From: George Penokie (Tivoli Systems)

Subject: Defining Traget/Initiators as Ports

What follows are suggested changes to SAM that would define targets and initiators as ports and allow multiples on a single SCSI device.

Figure 1 - Multiple port target SCSI device structure model

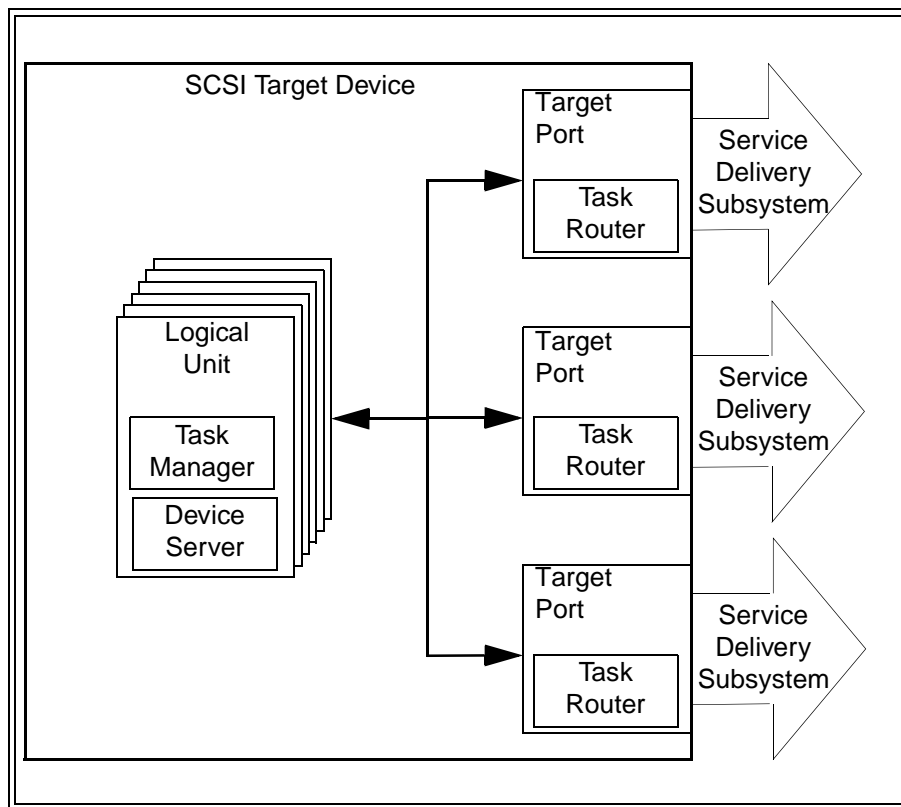
In looking over the issue of how SCSI should deal with multiple port devices it appears a reasonable solution would be to change the notion of what a target and initiator is defined as. If you confine a target or initiator to only contain a service delivery port and allow a SCSI device to contain any number of targets or initiators then defining multi-port devices becomes an easier task. In many ways the current definitions and descriptions already support this idea.

Figure 10 - SCSI Device hierarchy diagram

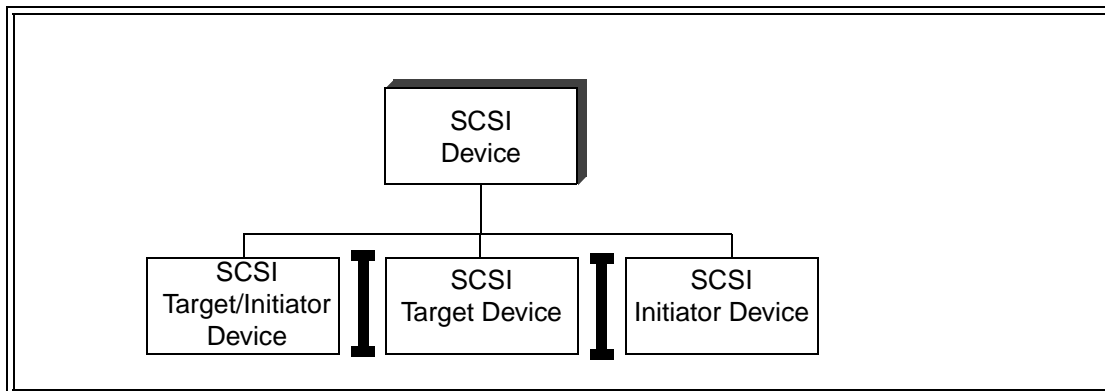
A SCSI device's (see figure 10) consists of a SCSI target device, a SCSI initiator device, or a SCSI target/initiator device.

A SCSI initiator device is capable of originating SCSI commands and task management requests (see xxx). A SCSI target device is capable of executing SCSI commands and task management requests (see xxx). A SCSI target/initiator device is capable of originating and executing SCSI commands and task management requests (see xxx). To be functional, a SCSI domain needs to contain a SCSI target device or a SCSI target/initiator device operating as a SCSI target device and another SCSI initiator device or SCSI target/initiator device operating as a SCSI initiator device.

Figure 11 - Initiator hierarchy diagram

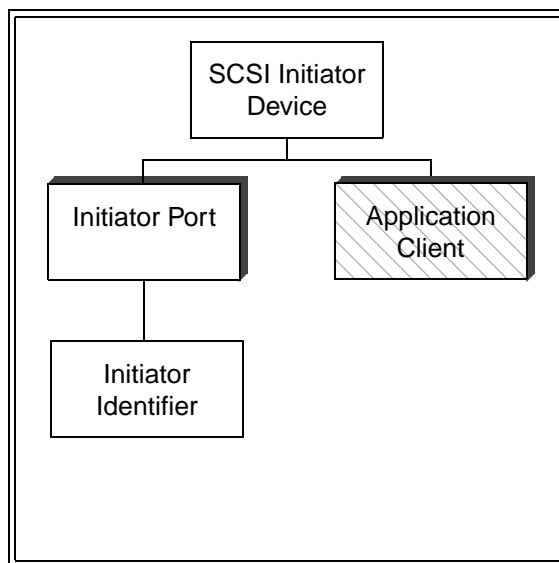
A SCSI initiator device (see figure 11) contains one or more initiator ports each having an initiator identifier and zero or more application clients.

An initiator identifier is a value containing up to 64 bits that is the SCSI device identifier for an initiator port. An application client is the source of commands and task management functions. A SCSI initiator device contains is one application client for each pending command or task management function.

Figure 12 - Target hierarchy diagram

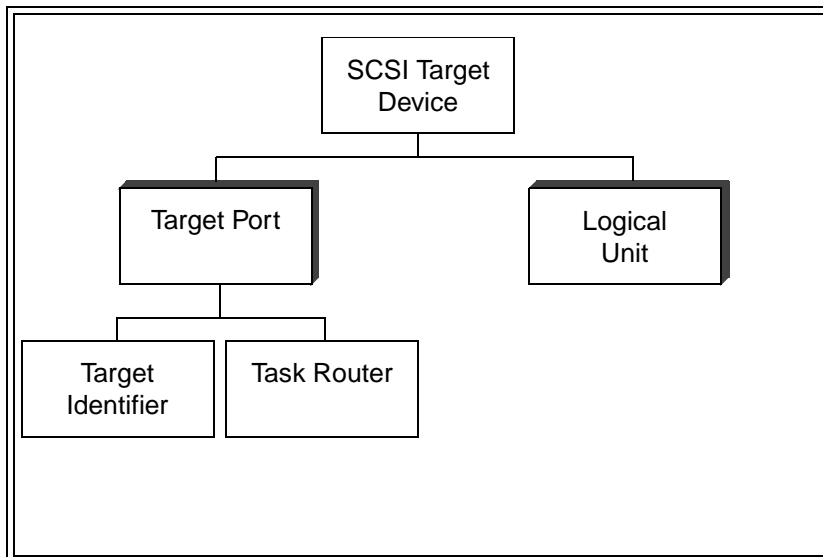
A SCSI target device (see figure 12) contains of one more target ports composed of a task router and target identifier and one or more logical units.

A target identifier is a value containing up to 64 bits that is a SCSI device identifier for a target port. A task router moves the commands and task management functions between the service delivery subsystem and the appropriate logical unit. A logical unit (see) is the object to which SCSI commands are addressed. One of the logical units within the SCSI target device shall be addressed using the logical unit number zero. SCSI target/initiator model.

Figure 13 - Target hierarchy diagram

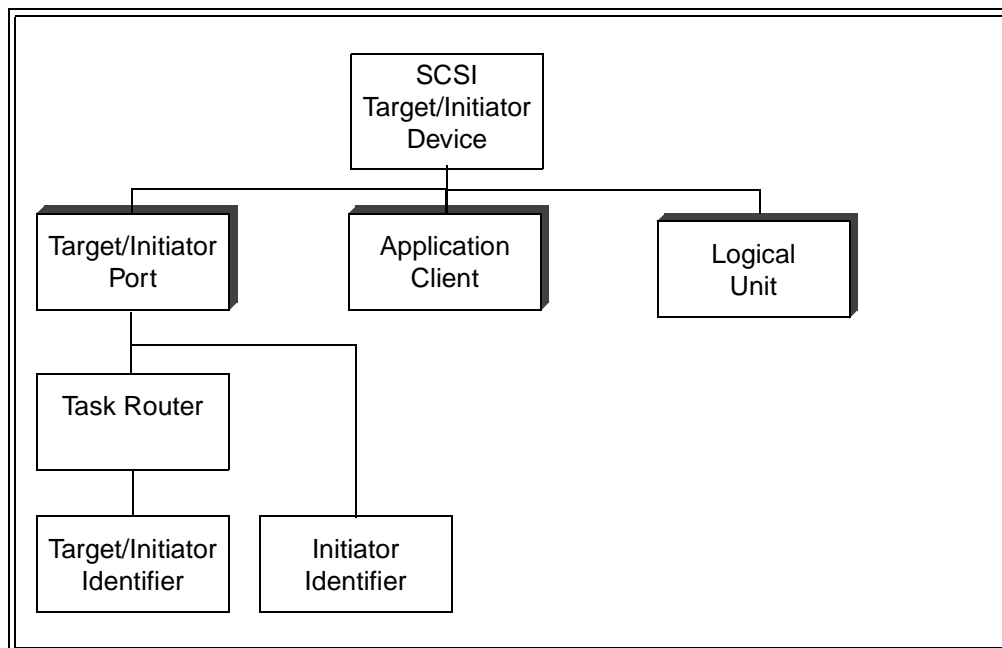
A SCSI target/initiator device (see figure 12) contains of one or more target/initiator ports composed of a task router and target/initiator identifier and one or more logical units.

The target/initiator identifier is a value containing up to 64 bits that is a SCSI device identifier for a target/initiator port.

Figure 14 - SCSI device functional models

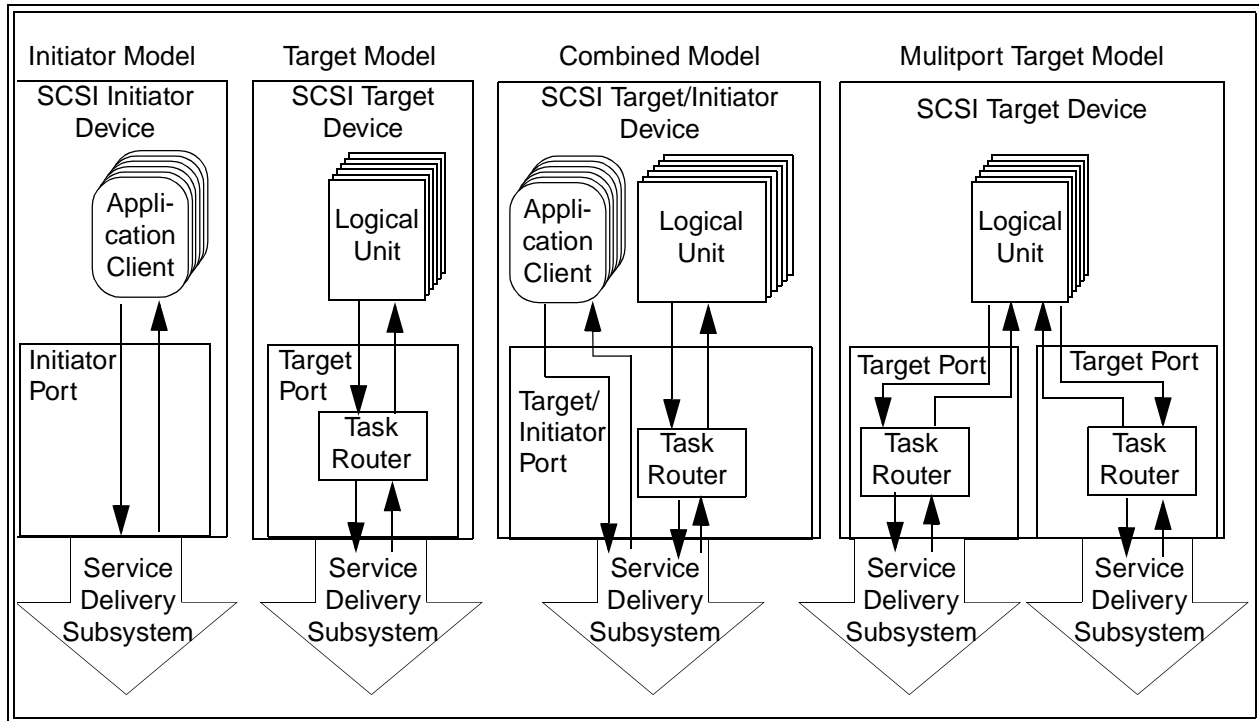
There are several models for implementing ports in an SCSI device, some are shown in figure 14. A SCSI device may contain only target ports, only initiator ports, only target/initiator ports or any combination thereof.

A target/initiator SCSI device is referred to by the role it's port takes when it participates in an I/O operation (i.e., when a SCSI target/initiator device receives SCSI commands or task management functions the SCSI target/initiator device takes on the characteristics of a SCSI target device, or when a SCSI target/initiator device issues SCSI commands or task management functions the SCSI target/initiator device takes on the characteristics of a SCSI initiator device).

Figure 16 - Multiple port target SCSI device structure model

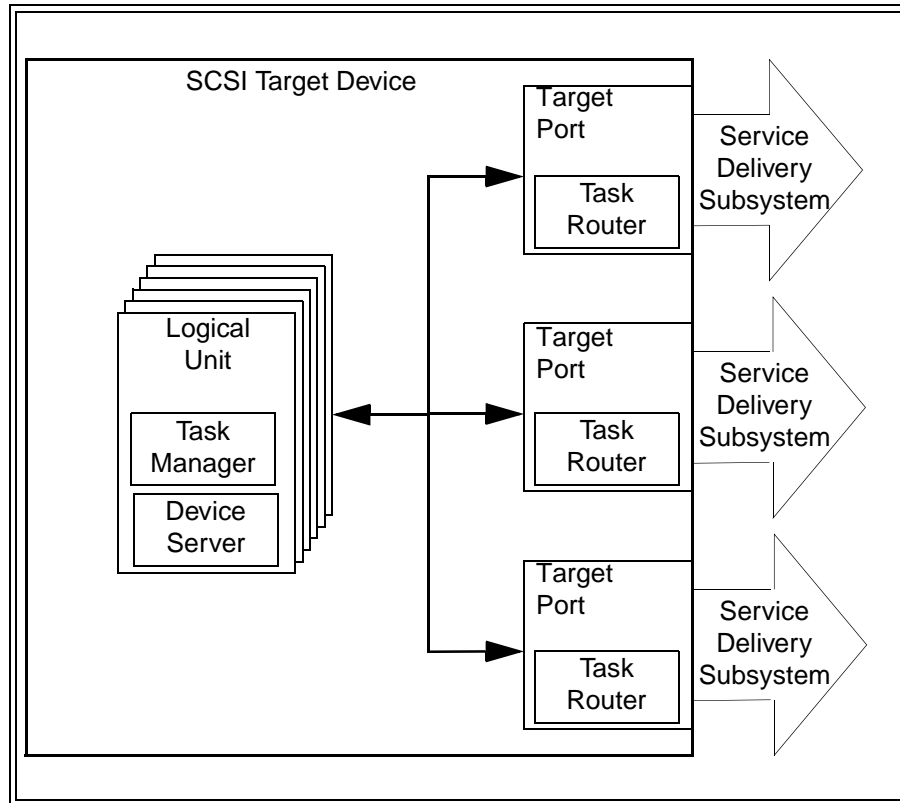
Figure 10 shows the structure of a SCSI target device with multiple target ports. Each target port consists of a task router and is shared by a collection of logical units. Each logical unit contains a single task manager and a device server.

Two-way communications shall be possible between all logical units and all target ports, however, communications between any logical unit and any target port may occasionally be inactive. Two-way communications shall be available between each task manager and all task routers. Each target port shall accept commands addressed to LUN 0 and the task router shall forward them to a device server for processing. The REPORT LUNS commands (see SPC-2) shall be accepted by logical unit 0 from any target port and shall return the logical unit inventory available via that target port. The availability of a the same logical unit through multiple target ports is discovered by matching device identifier values in the INQUIRY command vital product data page (see SPC-2).

Figure 17 - Multiple port SCSI initiator device structure model

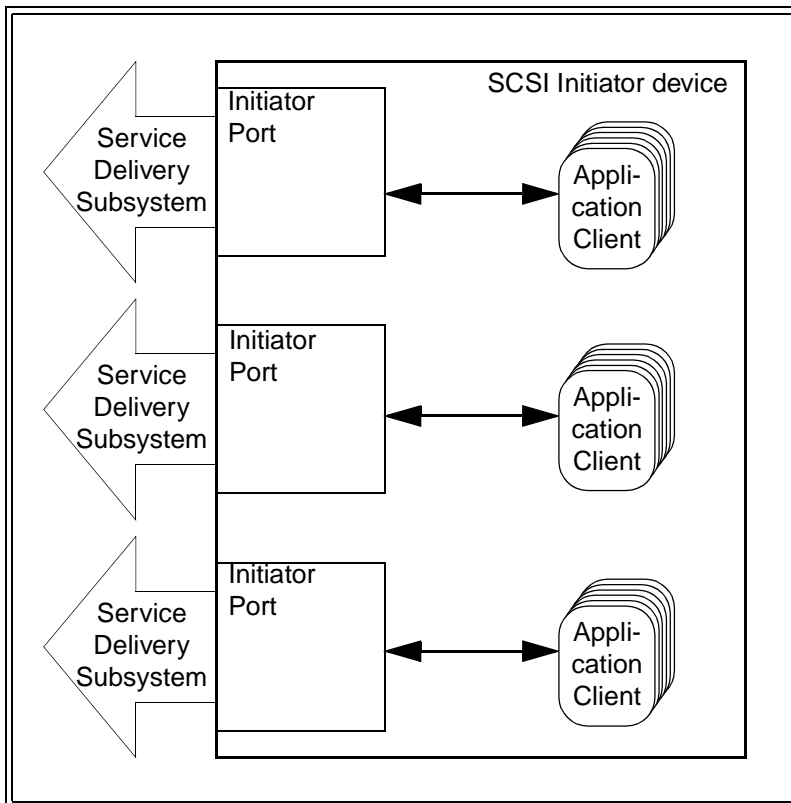
Figure 11 shows the structure of a SCSI initiator device with multiple initiator ports. Each initiator port is shared by a collection of application clients.

Two-way communications shall be possible between an application client and its associated initiator port, however, communications may occasionally be inactive. Mechanisms by which a SCSI target device would have the ability to discover that it is communicating with an initiator port are beyond the scope of any standards in the SCSI family of standards.

Figure 18 - Multiple port target/initiator SCSI device structure model

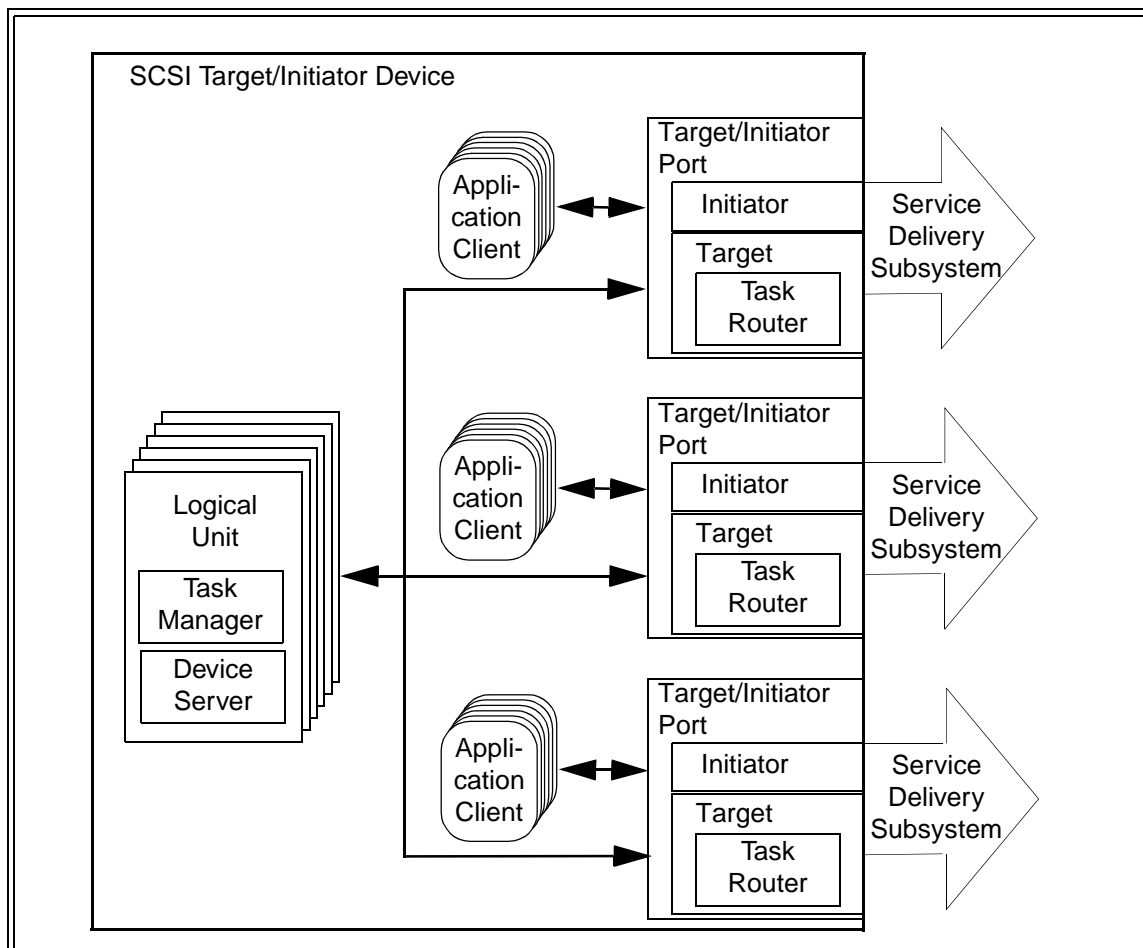
Figure 13 shows the structure of a SCSI target/initiator device with multiple target/initiator ports. Each target/initiator port consists of a task router and is shared by a collection of logical units. Each logical unit contains a single task manager, a device server, and an application client.

Two-way communications shall be possible between all logical units and all target/initiator ports, however, communications between any logical unit and any target/initiator port may occasionally be inactive. Two-way communications shall be available between an application client and a target/initiator port. Each target/initiator port shall accept commands addressed to LUN 0 and the task router shall forward them to a device server for processing. The REPORT LUNS commands (see SPC-2) shall be accepted by logical unit 0 from any target port and shall return the logical unit inventory available via that target port. The availability of a the same logical unit through multiple target/initiator ports is discovered by matching device identifier values in the INQUIRY command vital product data page (see SPC-2).
